HiePRO SOLICITATION B25000415 Goulds Pumps
 Natural Energy Laboratory of Hawaii Authority.

QUESTION 1:

Plan set drawing for the 3409L 18x14x23 200hp Goulds Pump:

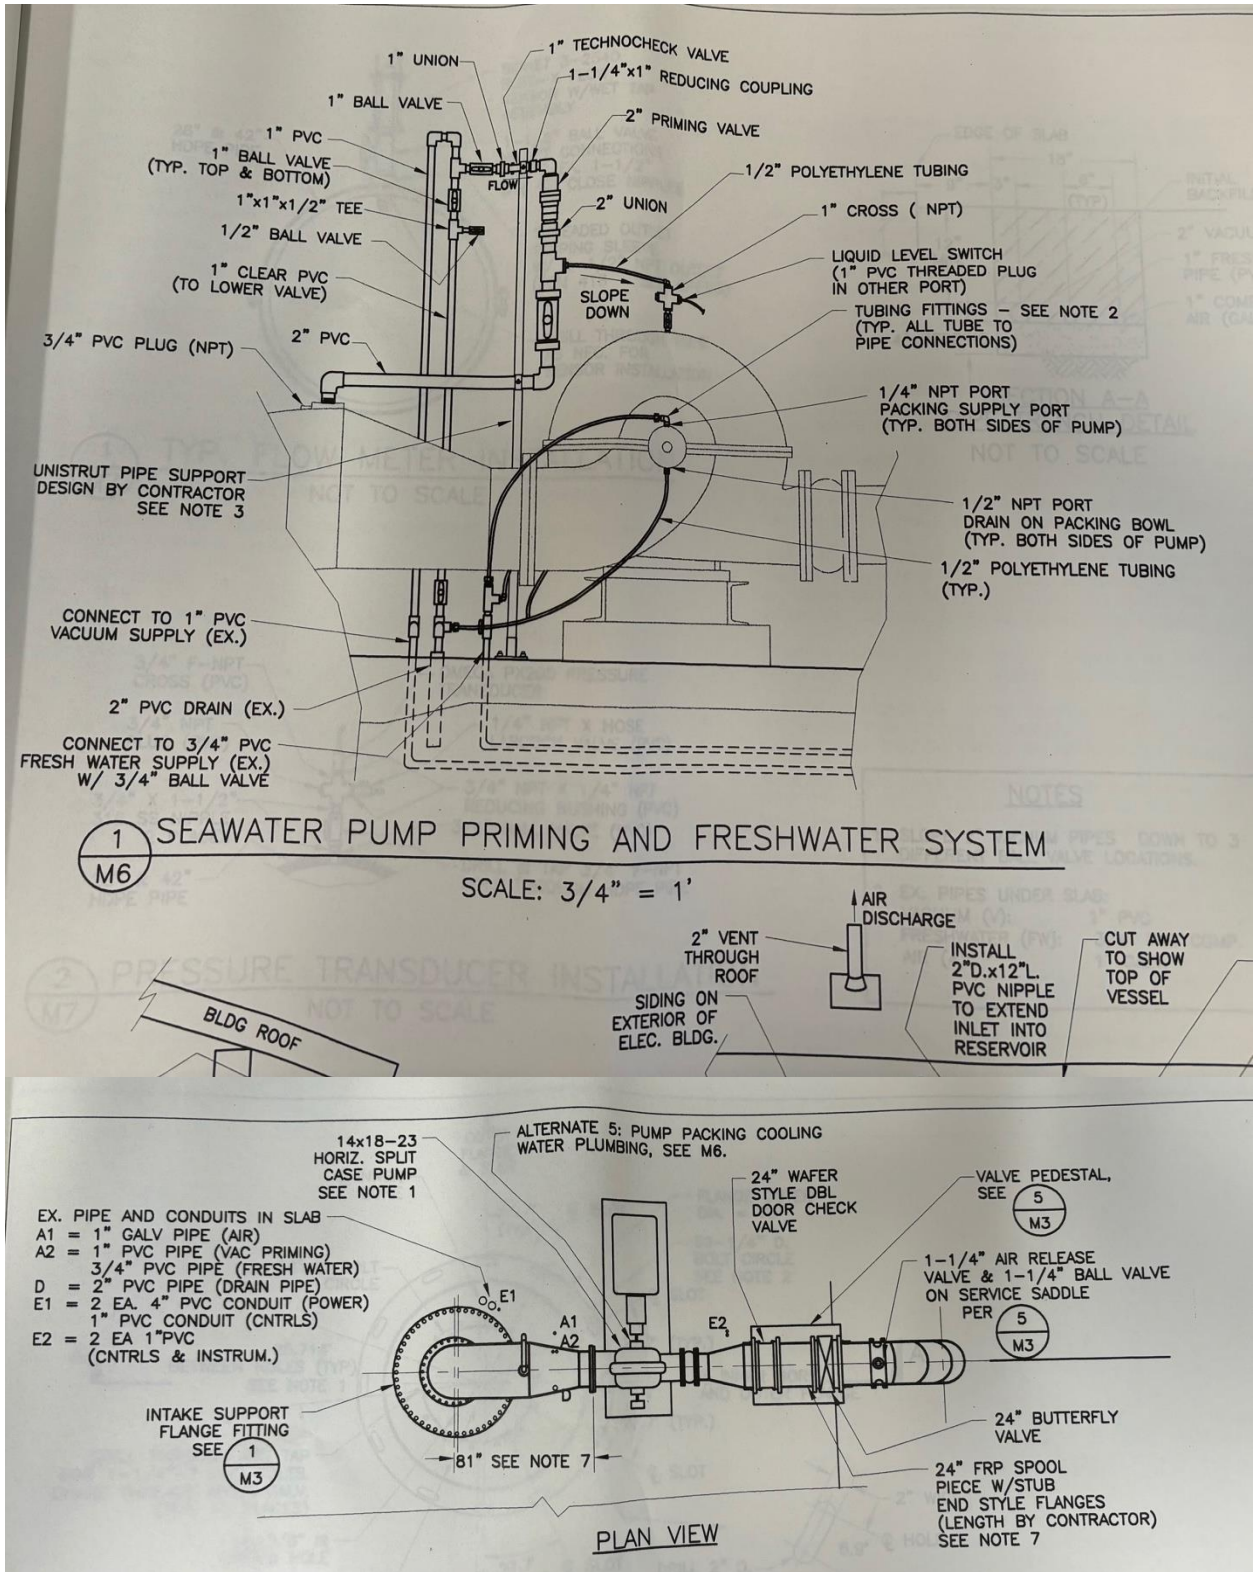
Are there any drawings for the existing pumps to know what to provide in the quote, per specification? "Any pumps offered that are not an exact match will need to include in the bid price all piping, hardware adapters, and fittings modification to allow the pumps to work within the framework of the current pump station design."

Dimensional drawings are non-existent in our plan sets. The plan set does provide general configuration information of the complete pump package, pump, motor, baseplate and coupling for the 3409L 18x14x23, 3410M 6x8-11 and 3419M 8x10-12 pumps. Goulds Pump provides dimensional diagrams of the complete pump package that was included in the specification document in the HiePRO Solicitation. This information can provide guidance in assessing the necessary additional parts needed to insert a pump not dimensionally similar to the existing Goulds Pumps, including the ancillary equipment and connections (vacuum pump and packing water connections) necessary to be utilized in our current system.
